MIL-R-83536/6
AMENDMENT 3
15 December 1998
SUPERSEDING
AMENDMENT 2
15 December 1995

MILITARY SPECIFICATION SHEET

RELAYS, ELECTROMAGNETIC, ESTABLISHED RELIABILITY, 4PDT,
LOW LEVEL TO 5 AMPERES, PERMANENT MAGNET DRIVE, HERMETICALLY SEALED,
ALL WELDED, TRANSIENT SUPPRESSED DC COILS

This amendment forms a part of MIL-R-83536/6, dated 27 March 1992, and is approved for use by all Departments and Agencies of the Department of Defense.

CIRCUIT DIAGRAM (NO MOUNT, RVFM, HFH AND TRACK MOUNT A)
(OPTIONAL INTERNAL
DIODE CONFIGURATION)

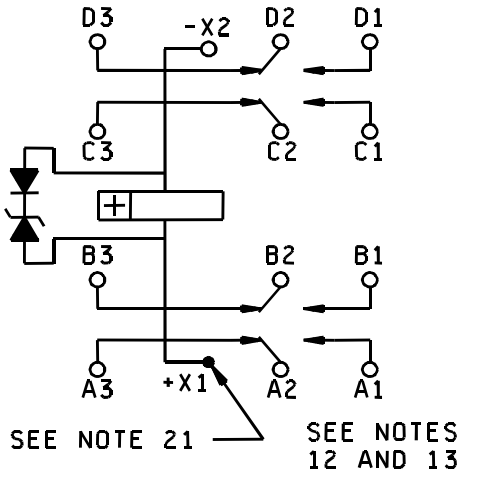
Add the following circuit diagram:
